Item Name: Baggage Compartment Protector - Floor And Wall

Work Order ID 155116***155116***

DART SERVICE INSTRUCTION

TO AMEND INSTALLATION INSTRUCTIONS IIN-D407-781-2 REV. A OR LATER APPROVED REVISION
AND INSTRUCTIONS FOR CONTINUED AIRWORTHINESS ICA-D407-781 REV. 3 OR LATER REVISION

**FIGURE 1 - D3879-1 BAGGAGE COMPARTMENT WALL
PROTECTOR - ALTERNATE INSTALLATION**

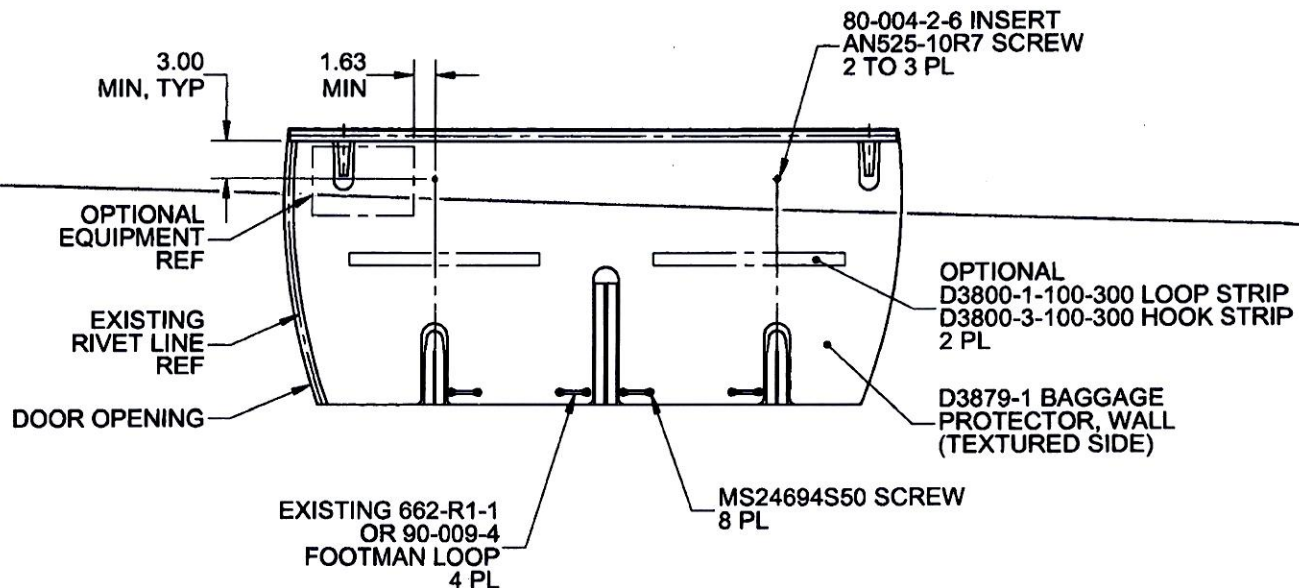
In some aircraft, the top portion of the D206-781-041 Baggage Compartment Wall Protector Kit cannot be installed as indicated in IIN-D407-781-2. The purpose of this DSI is to provide an alternate mounting method to fasten the top portion of the D206-781-041 Baggage Compartment Wall Protector Kit.

It is acceptable to replace qty(2) D3930-1 Clips with qty(2) 80-004-2-6 Inserts. Locate and mark location of the two attachment holes on the baggage compartment wall as shown in Figure 1 of this service instruction. Install 80-004-2-6 Inserts at the marked locations in accordance with Section 3-2-12 of BHT-206-SRM-1. It is acceptable to trim the wall protectors to accommodate optional equipment or transfer attachment holes to the wall protector and install the optional equipment on top of the wall protector with longer fasteners.

Amend the D206-781-041 Baggage Compartment Wall Protector Kit parts list as follows:

Qty -061	Qty -031	Qty -041	Part Number	Description
X			D206-781-061	BAGGAGE COMPARTMENT PROTECTOR KIT (FLOOR AND WALL)
1	X		D206-781-031	BAGGAGE COMPARTMENT FLOOR PROTECTOR KIT
1		X	D206-781-041	BAGGAGE COMPARTMENT WALL PROTECTOR KIT
		2	AN525-10R7	SCREW
		2	80-004-2-6	INSERT
